Georgia Department of Transportation

East-West One-Way Pair from West
of NS #718408K to East of Henry St

P.I. 321530-

City of McDonough with Russell McMurry and Todd Long

Proposed Improvements (West of the Downtown Square)

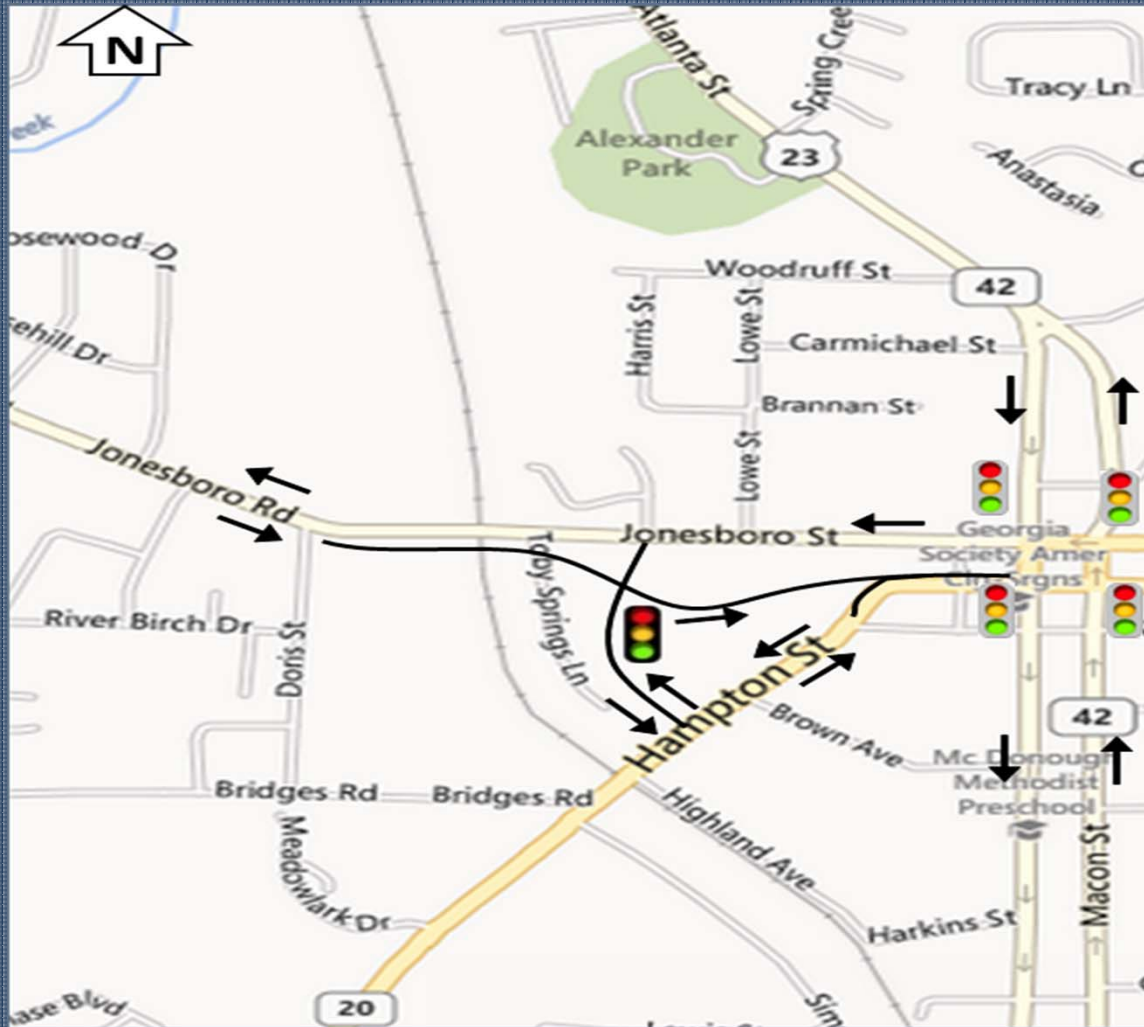
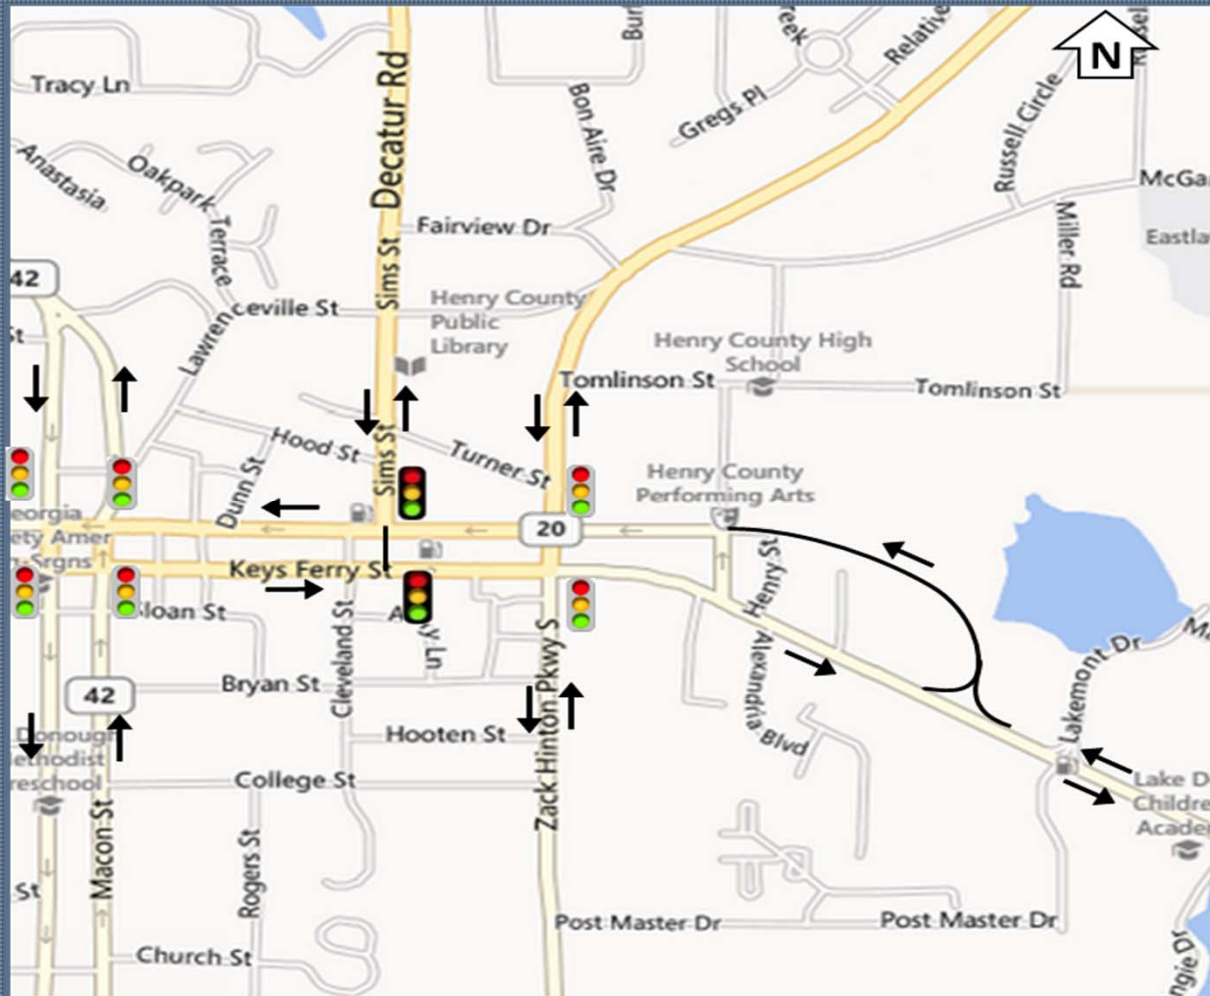
City of McDonough concerns:

- Two-way traffic vs. One-way traffic
- Sloan Street and Brown Avenue impacts
- Driving folks to “County” retail centers on Jonesboro Rd rather than “City” retail centers on SR 20/81
- Jonesboro Street from the Square to the RR crossing
- Eastside roundabout

Gateway/Roundabout Location

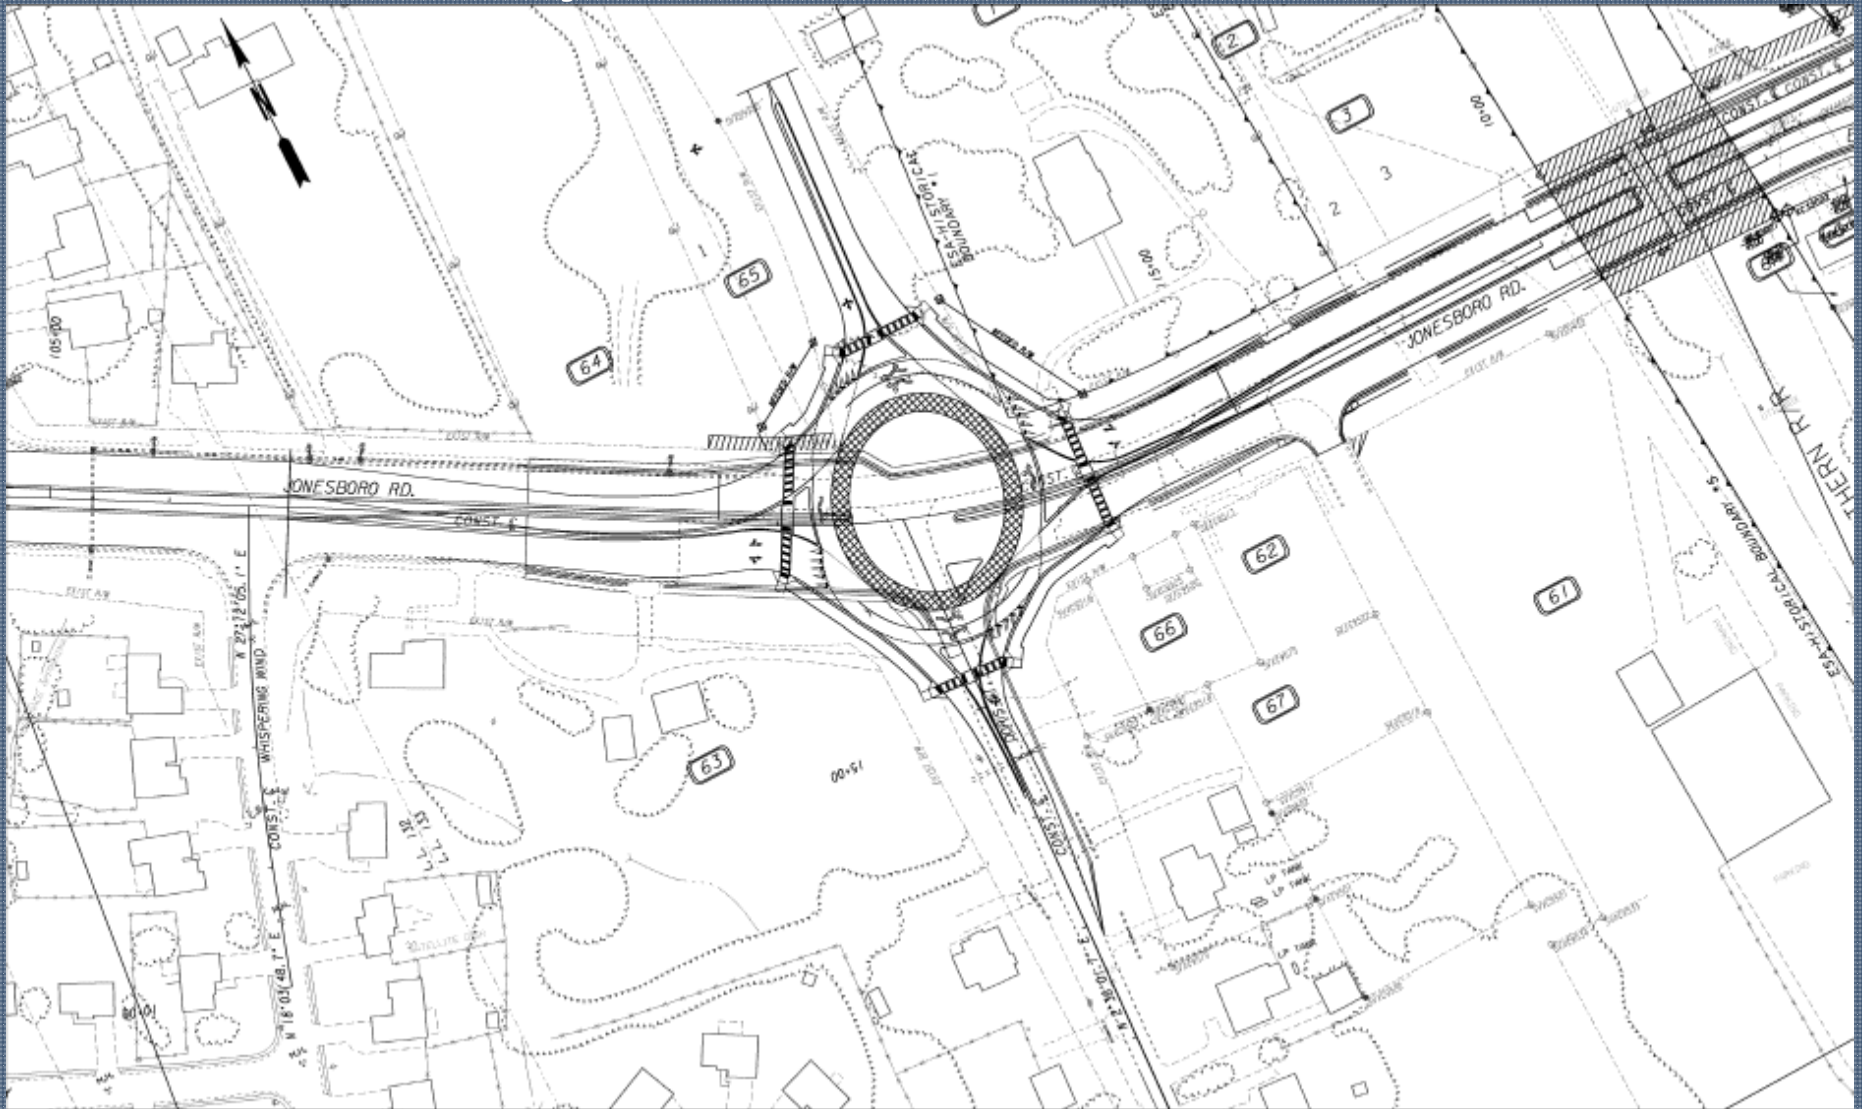
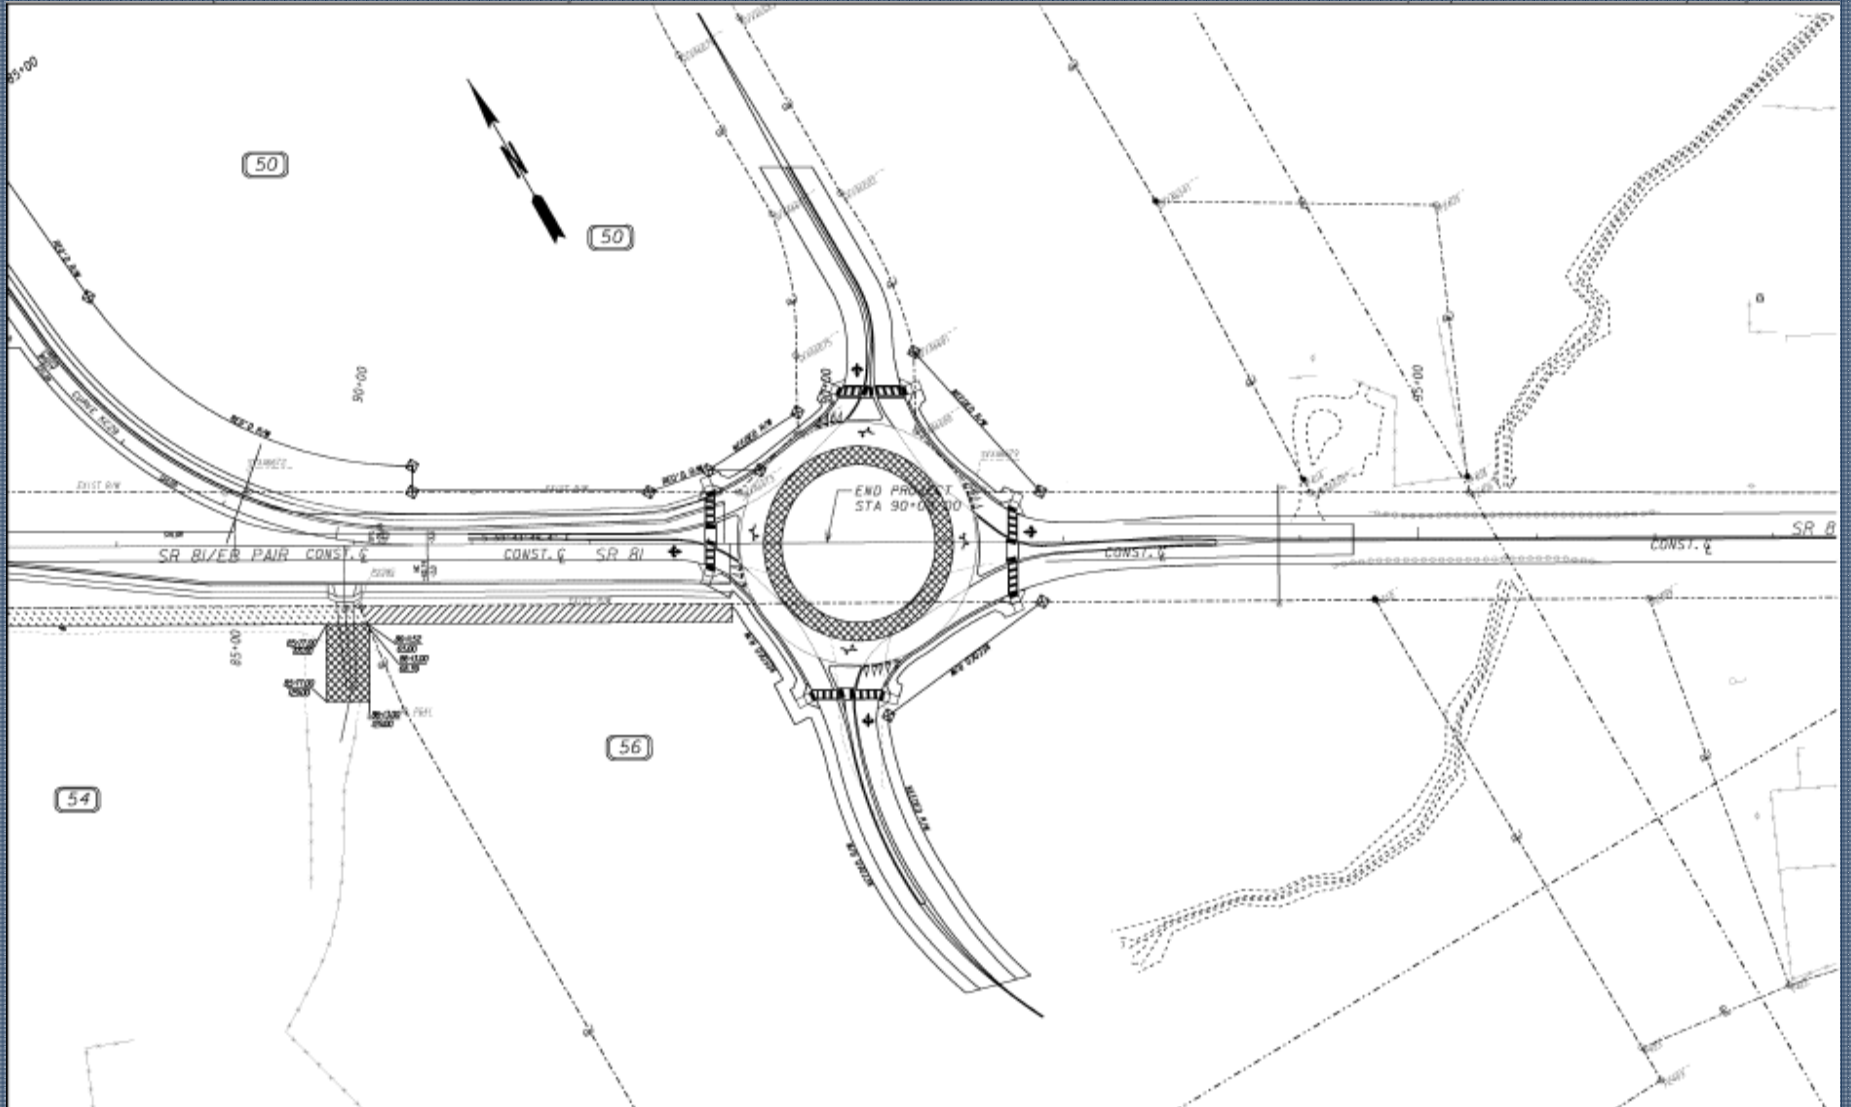
Impacts of the Roundabouts to the Project

- Scope of Work
- Schedule
- Budget
- Options for Roundabout designs
 - Include Roundabouts as part of this project (P.I. 321530-)
 - Program each roundabout separately
